MOONEY AIRCRAFT INC

~~SERVICE BULLETIN NO. 20-5~~
SERVICE BULLETIN M 20-5

SUBJECT: Relief Of Brake Pedals

MODELS AFFECTED: M-20 Serial No. 1002 thru 1020

FIG 1

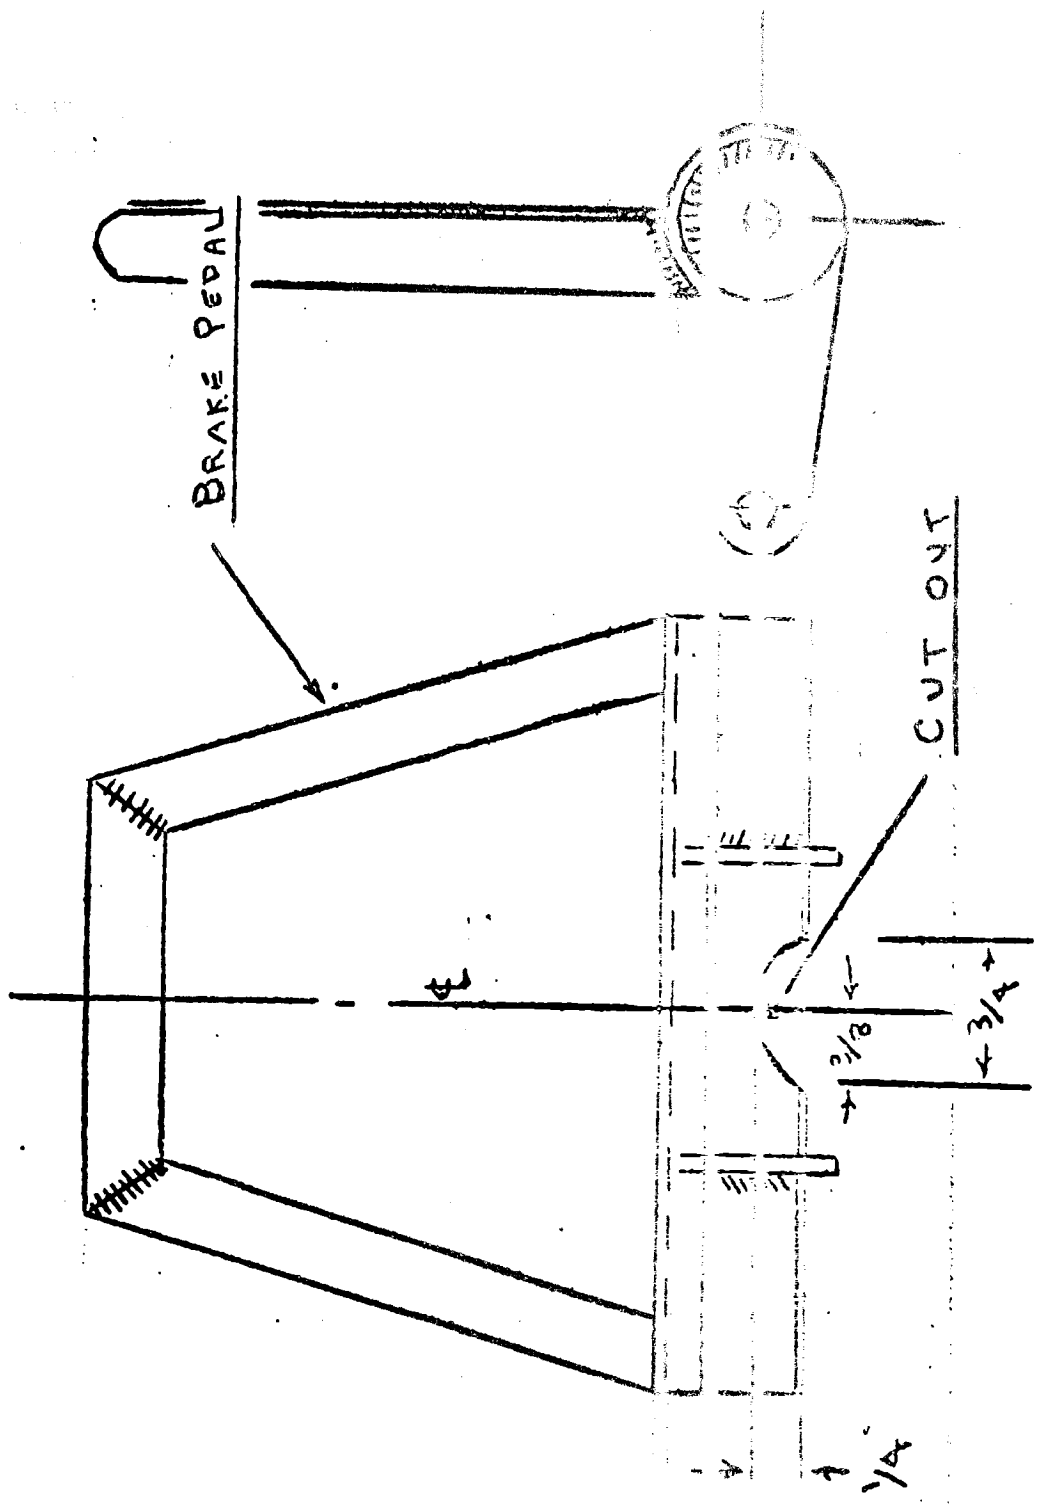
On the models affect it has been found that in some cases upon application of full left or right rudder the brake, on the side where the rudder is applied, will lock. This situation will be eliminated if a relief cut out is made in the lower part of the brake pedals as shown in figure 1.
